Mr. Dwight Russell, P.E.
Municipal Solid Waste Permits Section – MC 124
Texas Commission on Environmental Quality
12100 Park 35 Circle; Bldg. F
Austin, Texas 78753

Re: Pescadito Environmental Resource Center - Webb County
Municipal Solid Waste (MSW) Permit Application No. 2374
Notice of Deficiency - Technically Complete Permit Application Supplement Number 5
Tracking No. 21876231; CN603835489/RN106119639

APTIM Environmental and Infrastructure, Inc. is in receipt of your letter dated October 23, 2017 in which you are asking for additional information and clarification related to our submittal of August 17, 2017.

**FIGURE 2 - PART I
DETAILED LOCATION MAP**

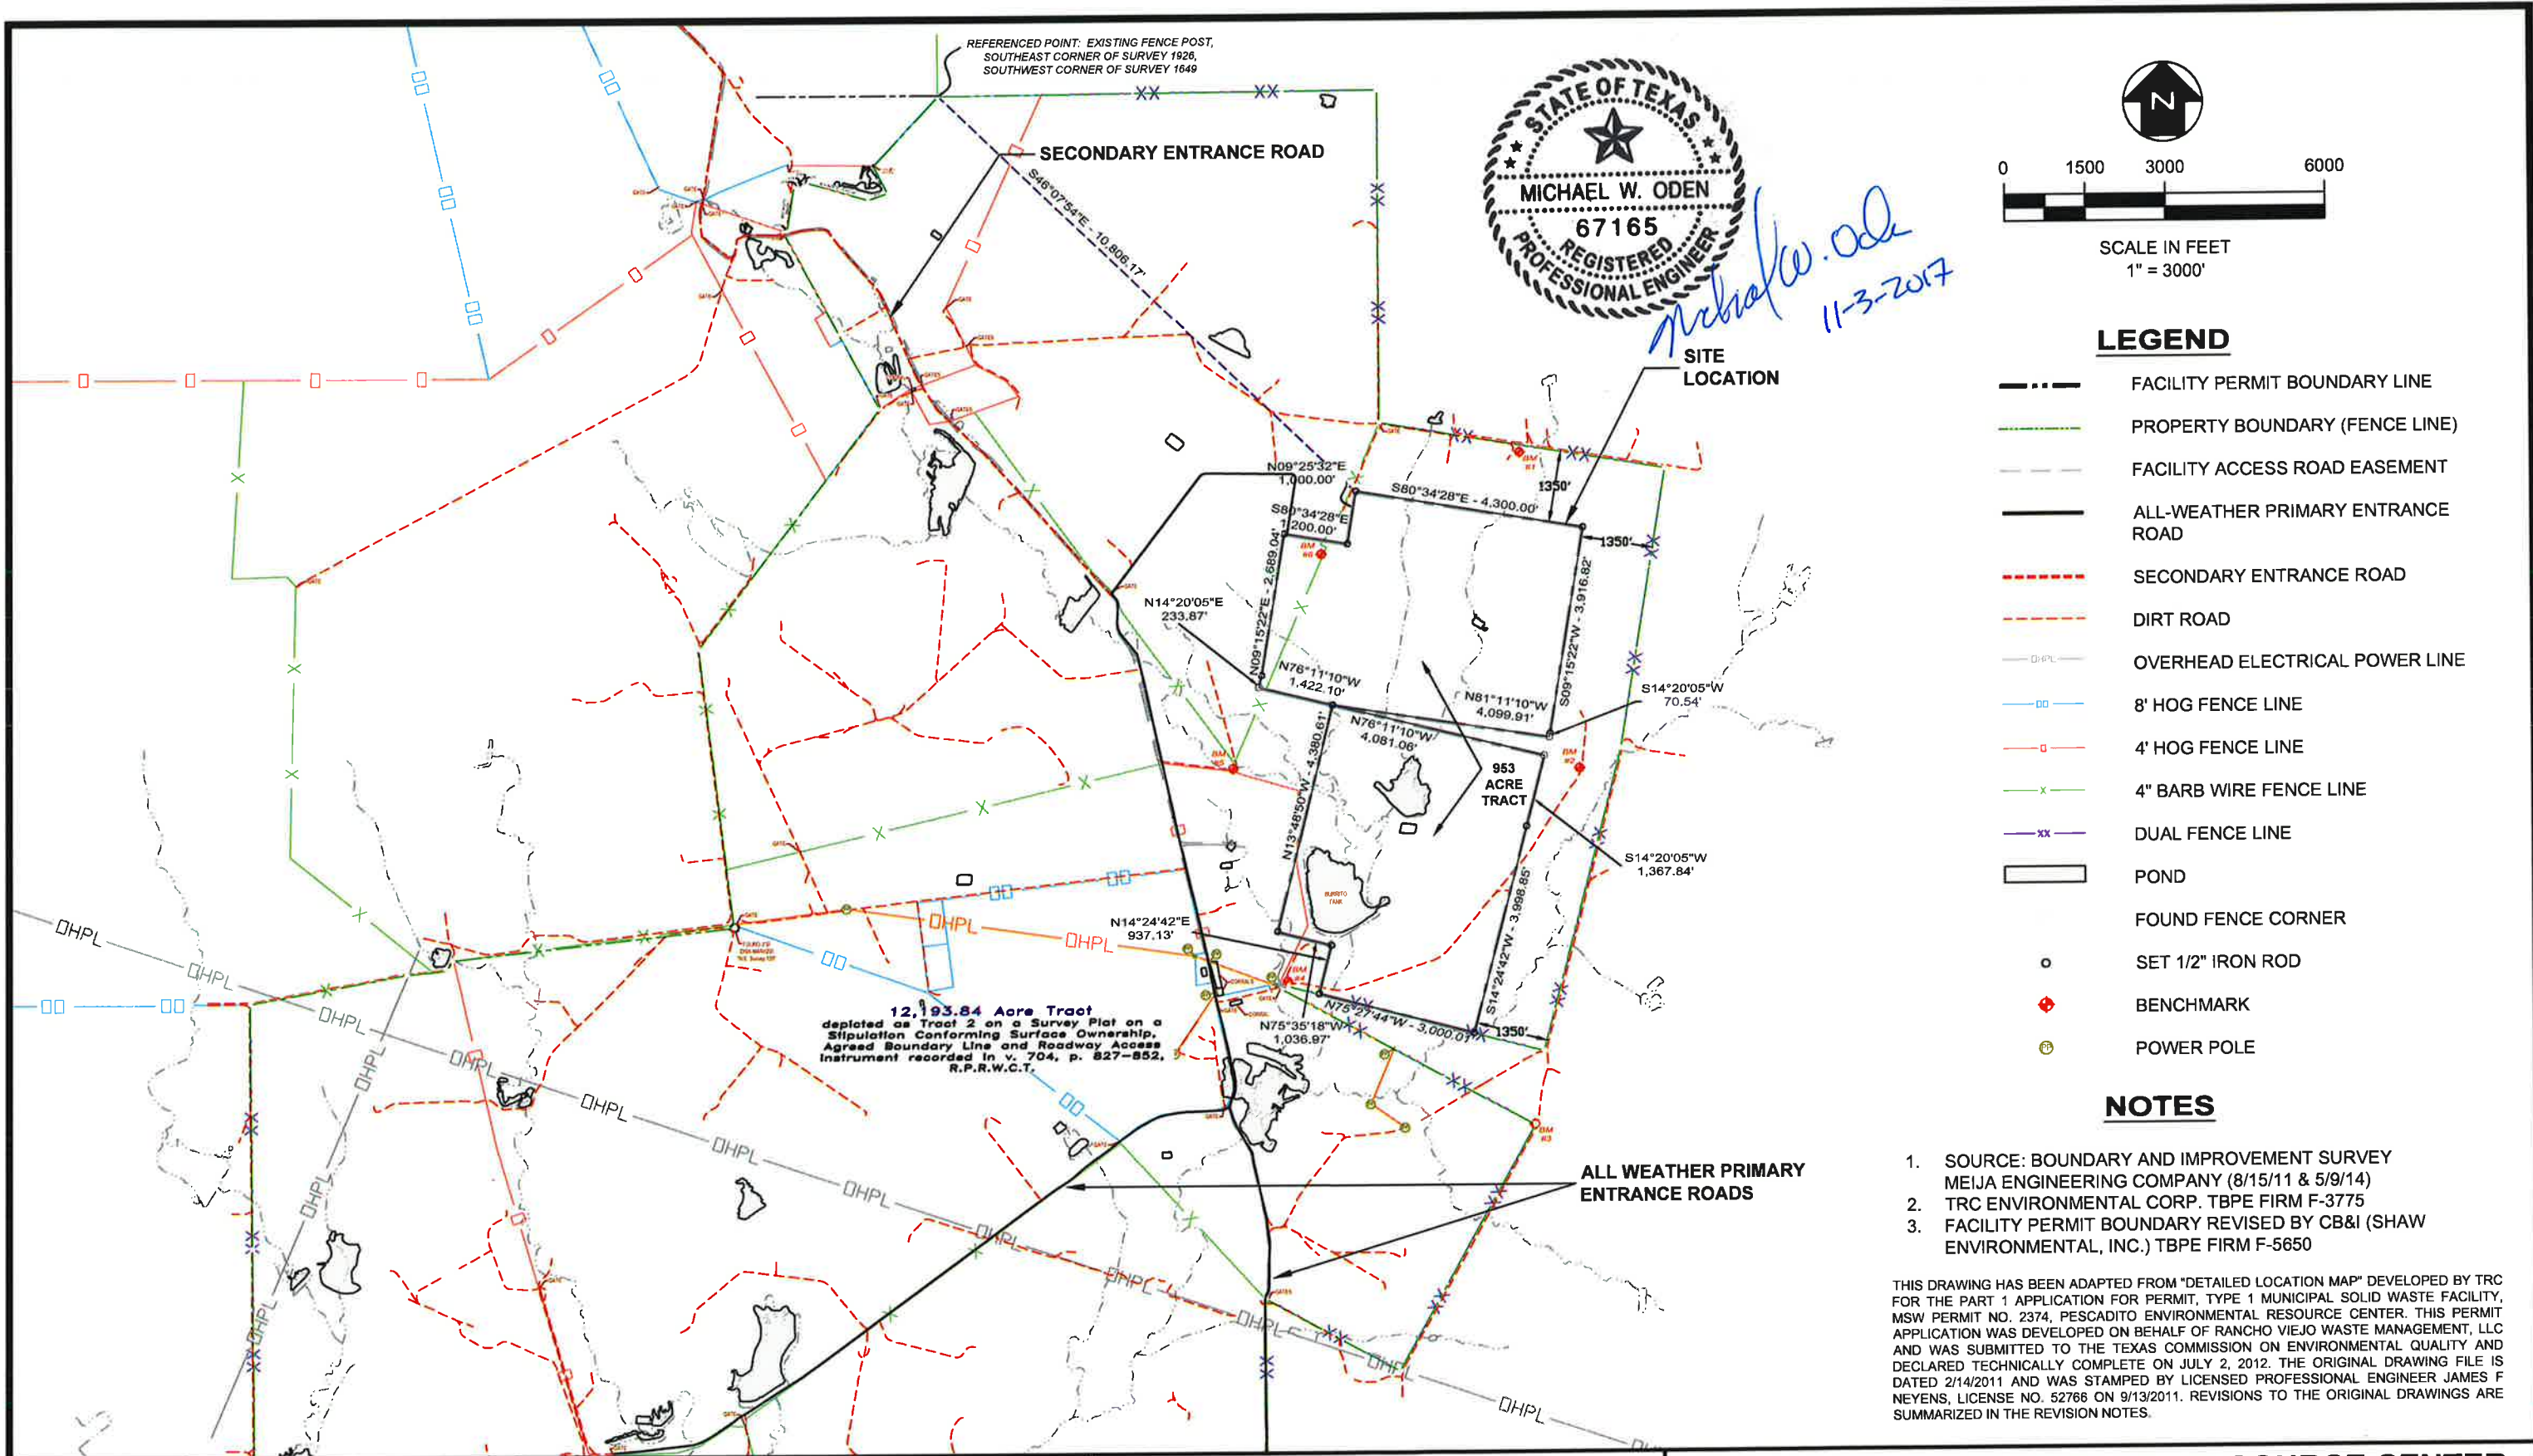
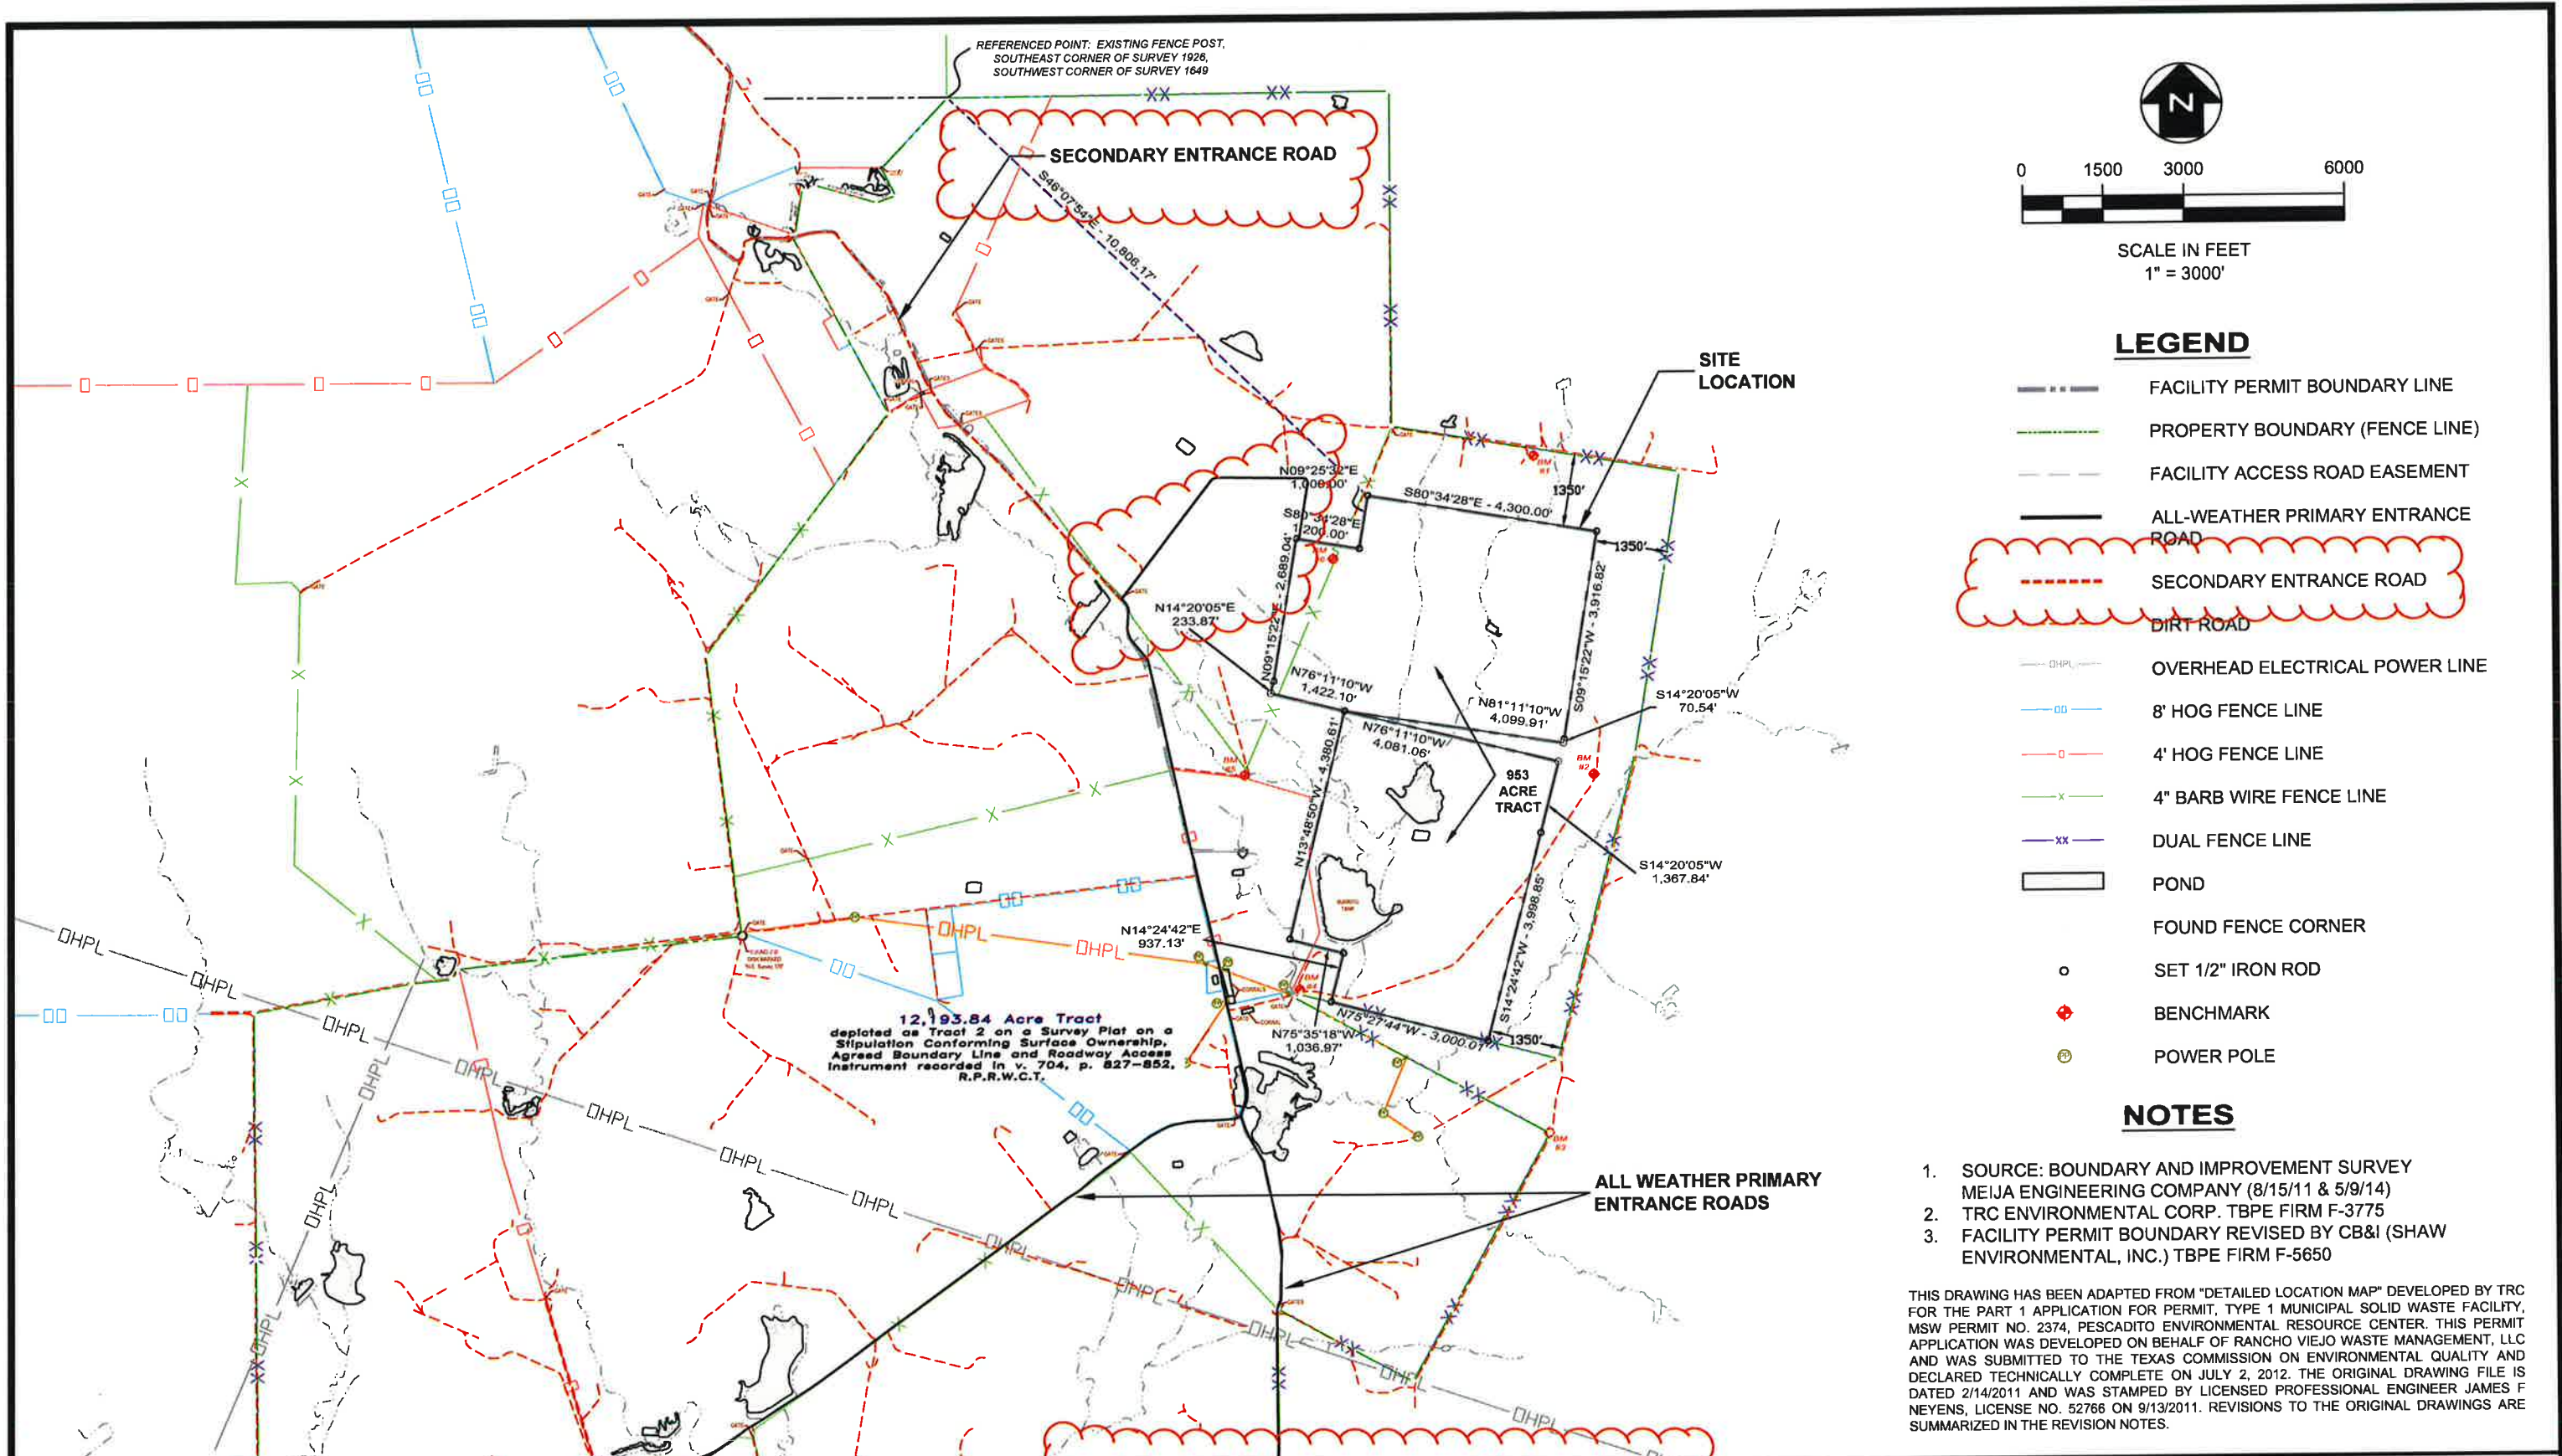
- 1) In accordance with §330.61(d)(8), Part I, Figure 1 should be revised to accurately depict the site entrance roads from public access roads north and south of the facility that are described in Part I, Page 5.

Part I, Figure 1 has been revised as requested. For consistency, Part I, Figure 2 has been revised as well.
